# ENGINEERING CHANGE NOTICE

| 2. ECN Category (mark one) | 3. Originator's Name, Organization, MSIN, and Telephone No. | | 4. Date |
|---|---|---|---|
| | 5. Project Title/No./Work Order No.<br>B-714 Grout Disposal Facility | 6. Bldg./Sys./Fac. No.<br>218-E-16 | 7. Impact Level<br>2 |

BLOCK 5: B-714, GROUT VAULT PAIR (218-E-16-102 & 103) (218-E-16-104 & 105) /ER8007

| KAISER ENGINEERS HANFORD | ENGINEERING CHANGE NOTICE SKETCH | | | | | |
|---|---|---|---|---|---|---|
| H-2-77593 | 1 | 0 | TERESA EHRHARD | [illegible] | B-714-41 | 3/3 |

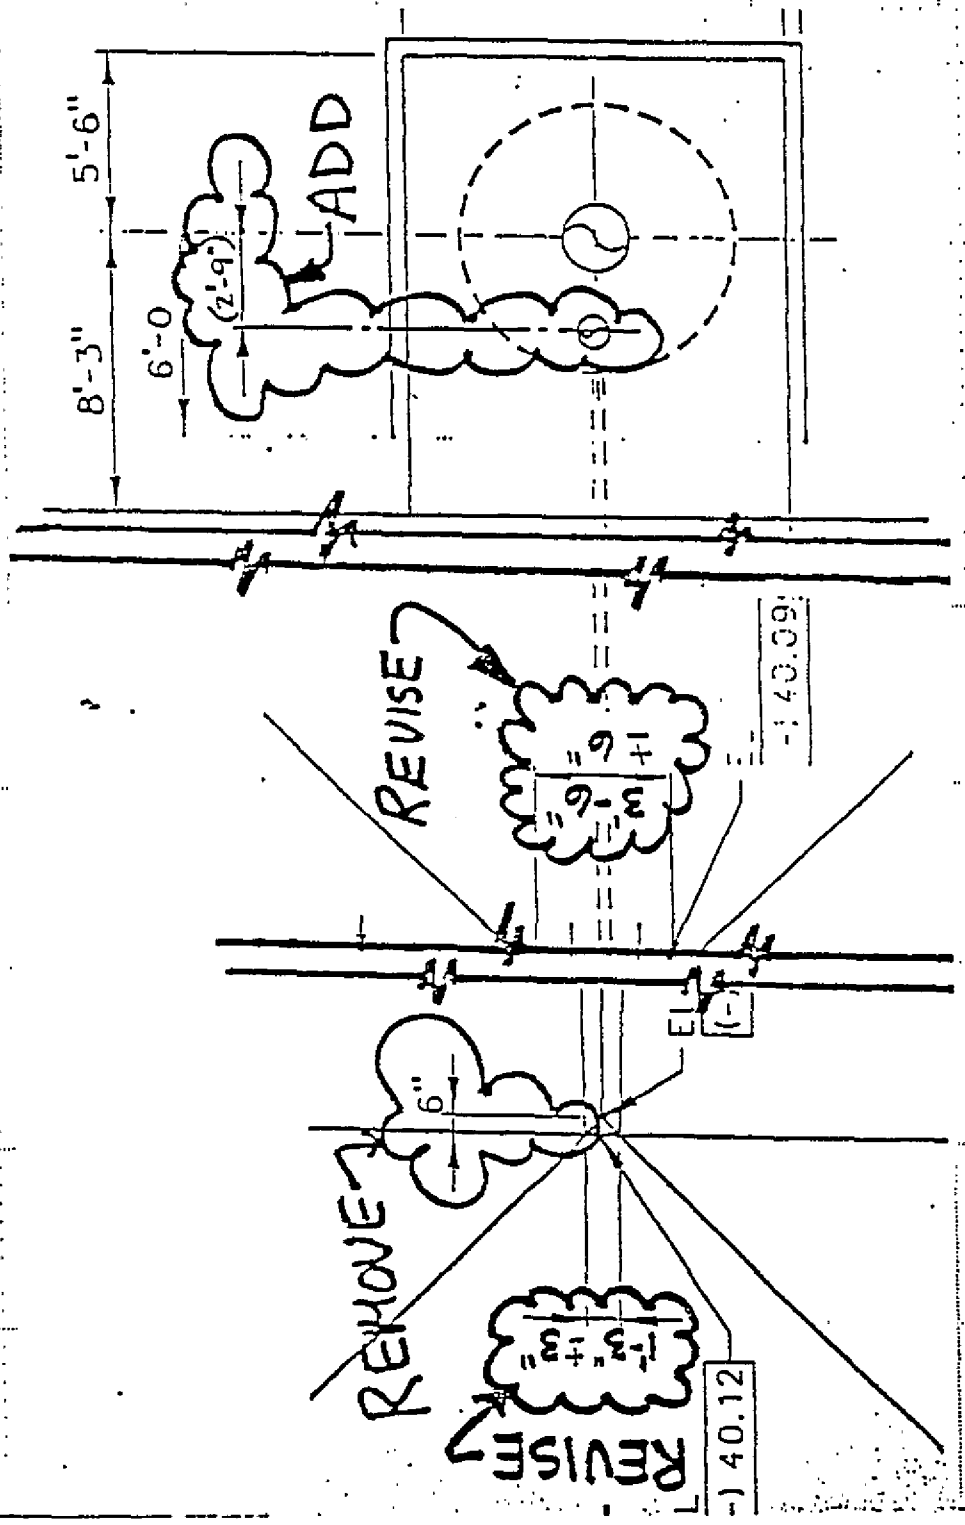
AFFECTED DOCUMENT: ECN B-714-24, PAGE 16 (Ref: H-2-77593, SH 1, REV 0 &
H-2-78455, SH 1, REV 0)

VOID PAGE 16 of the ECN and REPLACE with page 3 of this ECN.
